CITY OF WATERTOWN, NEW YORK
AGENDA
Monday, August 21, 2017

Subject: Approving the Site Plan for the Construction of a 640 Square-Foot Building Addition, a 2,300 Square-Foot Concrete Loading Dock and Associated Site Improvements at 830 Washington Street, Parcel Numbers 14-02-101.110, 14-08-111.000, 14-08-101.002 and 14-08-110.000

SAMARITAN MEDICAL CENTER SECONDARY LOADING DOCK PROJECT

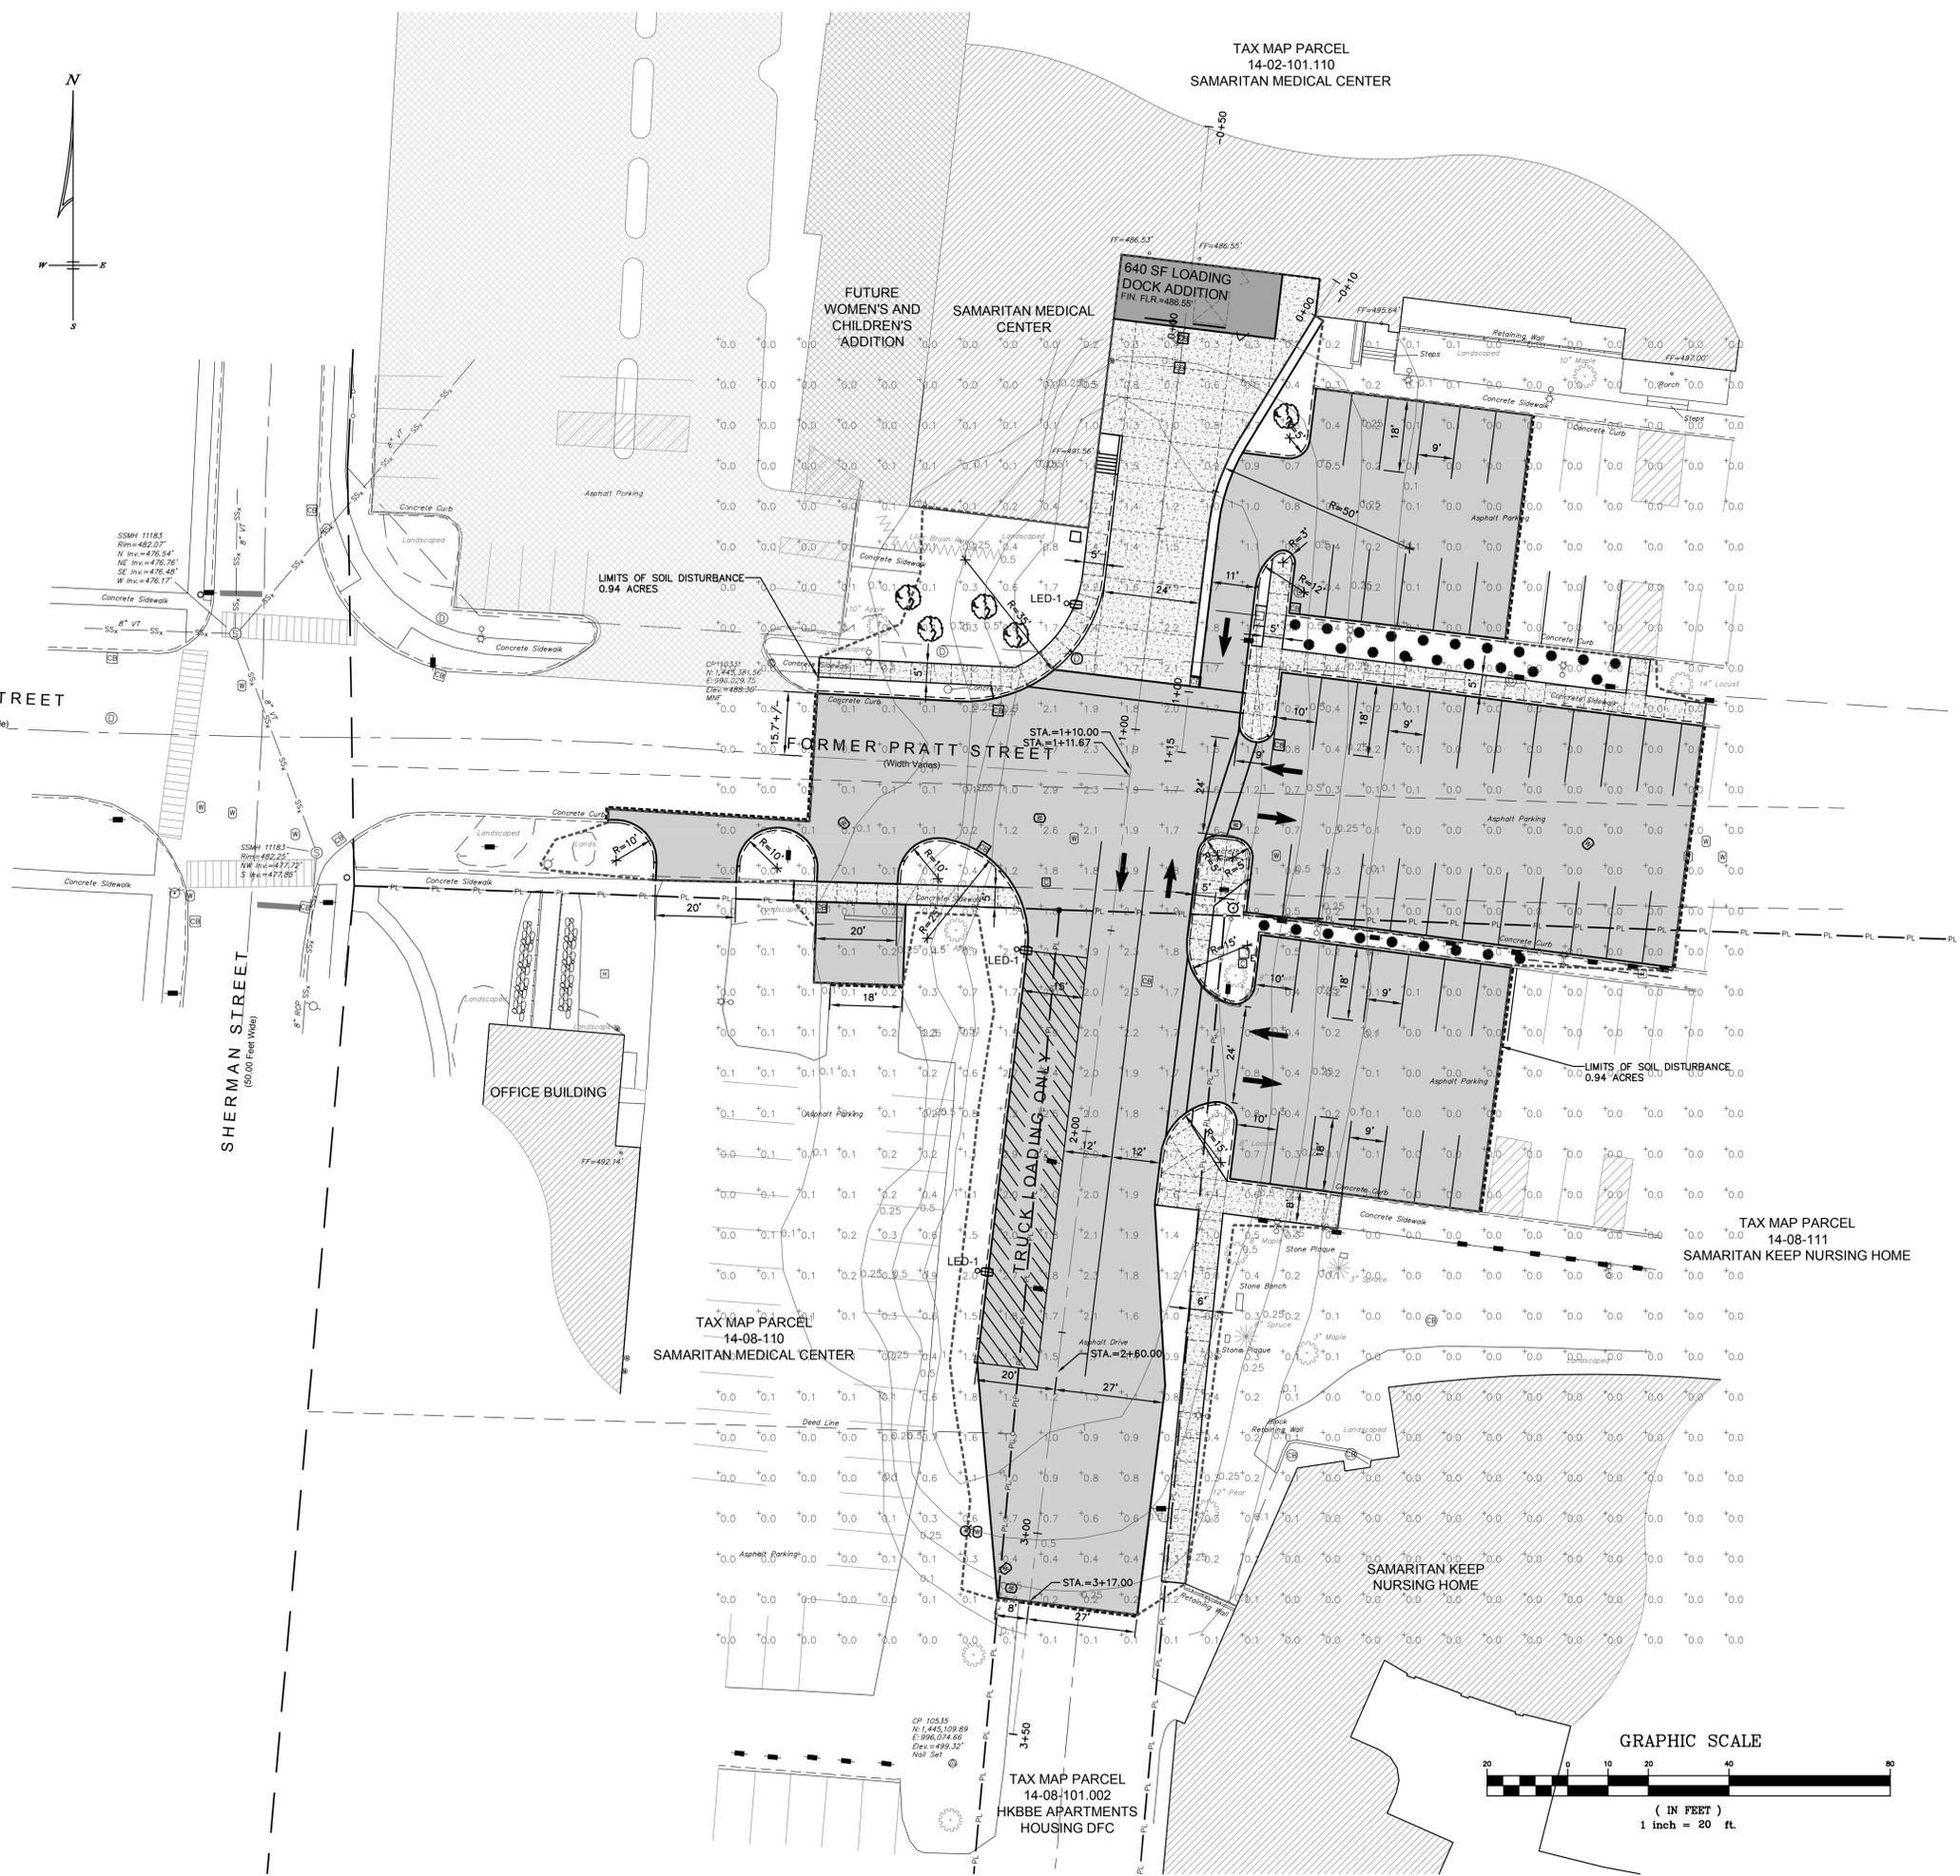
1. The applicant shall add a Planning Data table to the site plan that contains all relevant zoning information and parking calculations.
2. The applicant shall label all ADA accessible parking spaces on the site plan.

3. The applicant shall expand the geographic area of topographic survey and site plan, depicted to such an extent that it includes, minimally, topographic information for the horseshoe-shaped drive aisle and abutting sidewalk to the immediate east of the parking areas proposed for reconstruction, performed and stamped by a licensed surveyor.

4. The applicant shall provide two additional shade trees in northern interior landscaped island that meet the criteria for interior parking lot landscaping as defined in the Landscaping and Buffer Zone Guidelines and shall update the planting schedule to reflect the species and quantities of all proposed plant material.

Mr. Morgia then went through the list of summary items on Staff's memorandum, one-by-one. He addressed the first summary item, which required the applicant to add a Planning Data table to the site plan that contained all relevant zoning information and parking

Mr. Morgia then addressed the second summary item, which required the applicant to label all ADA accessible parking spaces on the site plan. Mr. Morgia said that his team would update the drawing accordingly.

Mr. Morgia then addressed the third summary item, which required that the applicant expand the geographic area of topographic survey and site plan to include all the drive aisles and sidewalks adjacent to the project area. Mr. Morgia said that his team would make the change and explained to the Planning Board that the area Staff was concerned with stretched about 120 feet further east than the drawing's current extent.

Mr. Morgia then addressed the fourth summary item, which required the applicant to provide two additional shade trees in northern interior landscaped island and update the planting schedule to reflect the addition. Mr. Morgia said that the updated drawing would show the new trees as requested, and then pointed out two other existing trees that might need to be replaced, as they were directly over an electric line, and which the original site plan did not depict for removal.

calculations. Mr. Morgia said that the drawing he brought for display at the Planning Board meeting had the table, and that he would submit an updated drawing to Staff with the table on it.

Mr. Urda then said that with regard to the two trees over the electric line, Staff would look to verify that the applicant was providing five trees total in the parking lot under consideration. Mr. Urda explained that the two new trees that the summary item required, combined with three existing trees, brought the total to five. He added that if the applicant removed two of those existing trees, they would need to replace them as well adding two new trees to get the total number of trees to five, and that the applicant should work with Mr. DeMarco or Planning Director Michael Lumbis to satisfy this requirement.
